## DECLARATION FOR THE RECORD OF DECISION

Yeoman Creek Landfill  
Waukegan, Illinois

## **RECORD OF DECISION SUMMARY**

U.S. EPA RESPONSES TO PUBLIC COMMENTS ON THE  
EVALUATION OF ALTERNATIVES AND PROPOSED PLAN FOR THE  
YEOMAN CREEK LANDFILL SITE

LOCATION OF ACTIVE GAS COLLECTION TRENCH AND MAJOR COMPONENTS			
DATE	DATE	DATE	DATE
12-10-99	12-10-99	12-10-99	12-10-99
BY	BY	BY	BY
AL	AL	AL	AL
12-10-99	12-10-99	12-10-99	12-10-99

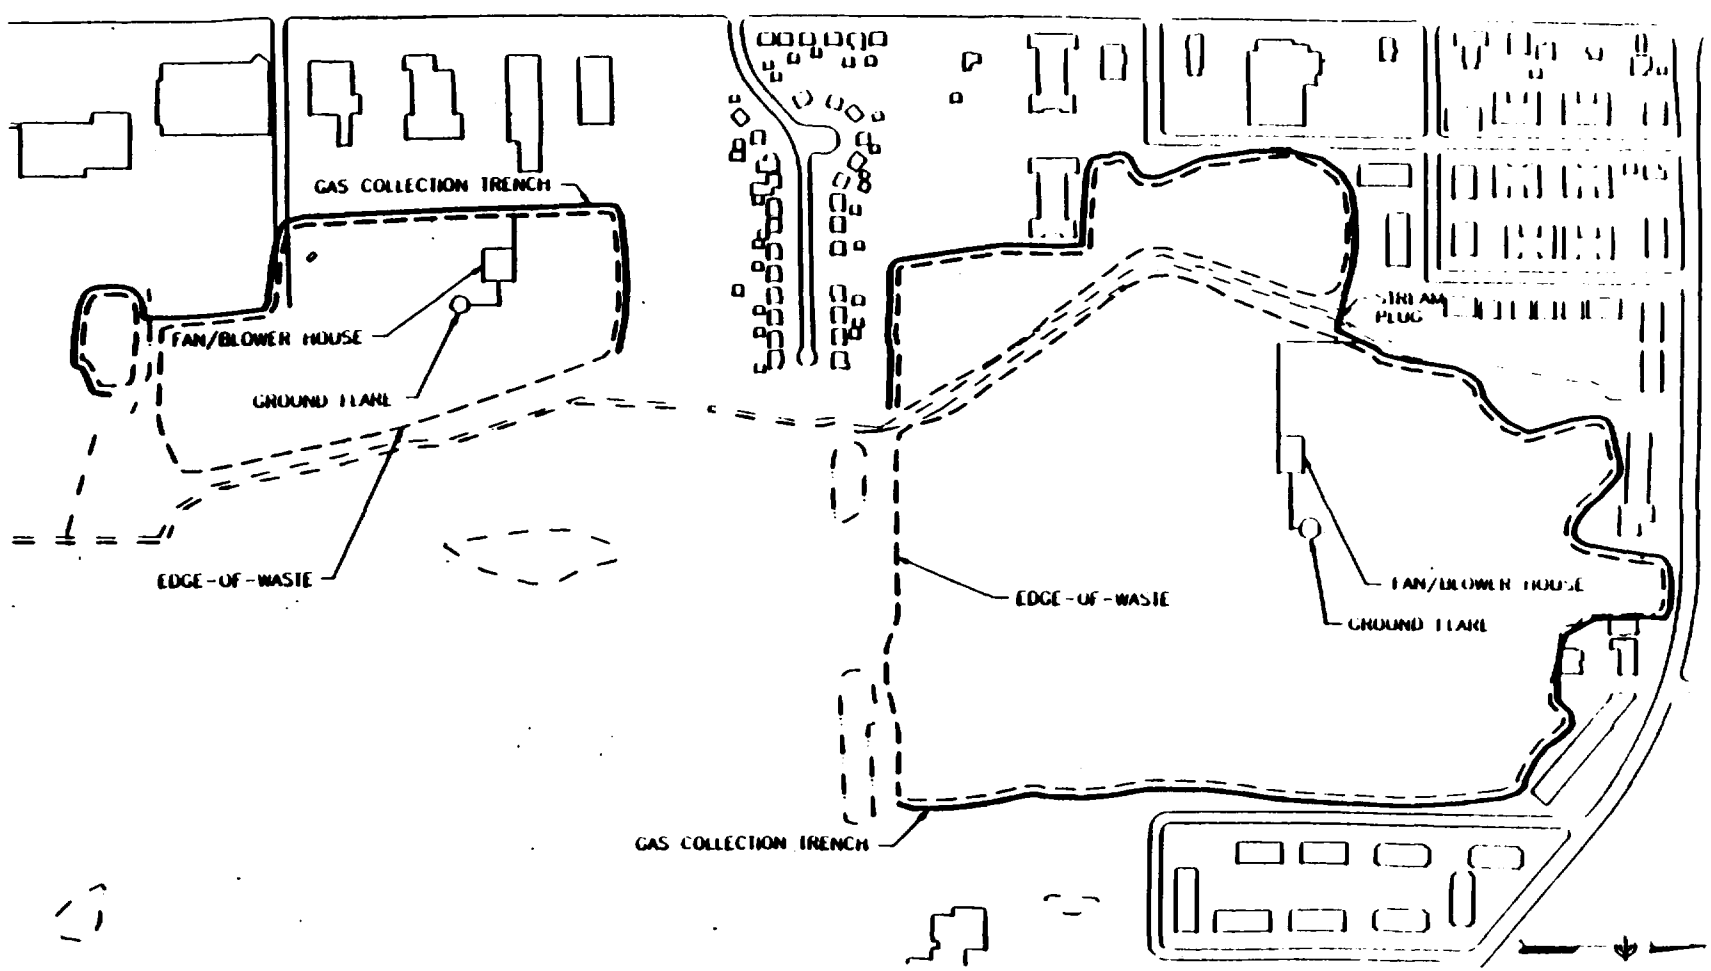
COMMENT 4 (July 15, 1995 letter): The cover recommended in the approved Feasibility Study (FS) provides the same degree of protection and reliability as the U.S. EPA preferred options.

COMMENT 5 (July 15, 1995 letter): The U.S. EPA unreasonably assumes that the FML will be poorly constructed and, hence, will not provide a reliable leakage barrier. Adding another layer is not the appropriate solution for increasing reliability.

COMMENT 6 (July 15, 1995 letter): The virtually identical performance offered by the U.S. EPA preferred cover does not justify the large additional cost.

U.S. EPA included the composite flexible membrane liner (FML)/ geosynthetic clay (GCL, cover Option 4A from the FS) or compacted clay (CC, cover Option 4B) barrier layer in the Proposed Plan because composite barrier layers have the potential to add considerably to the long-term effectiveness of the remedy in reducing infiltration of precipitation into the landfill compared to a site cover with only an FML barrier layer (cover Option 4). These options have been determined to be equivalent to or more stringent than the performance of 3 feet of compacted soil, with a hydraulic conductivity of  $10^{-7}$  cm/sec. We note that the ARAR for the landfill cap has been determined to be 35 IAC Part 811.314. The basis for this determination is discussed below after the technical merits of the questions are addressed. 35 IAC Part 811.314 provides some flexibility in designing the cover requirements, so long as they are equivalent to or exceed the performance of 3 feet of compacted soil with a hydraulic conductivity of  $10^{-7}$  cm/sec.

Under these circumstances the Agency's position is that a composite barrier layer is worth the 12-19% increase in cost compared to the cost of the site cover with an FML barrier layer (7-11% increase in the cost of the total remedy). In order to obtain the added long term protectiveness of a site cover having a composite barrier layer at a reduced cost, U.S. EPA is allowing a number of compromises of the normal hazardous waste capping requirements. This includes allowing a 2% slope instead of a 3% slope in order to reduce the quantity of soil that is needed for grading, allowing use of a GCL instead of two feet of CC, allowing use of the existing cover as part of a two foot CC layer, and allowing the CC to have a hydraulic conductivity of as high as  $10^{-6}$  cm/sec rather than the usual requirement of  $10^{-7}$  cm/sec.
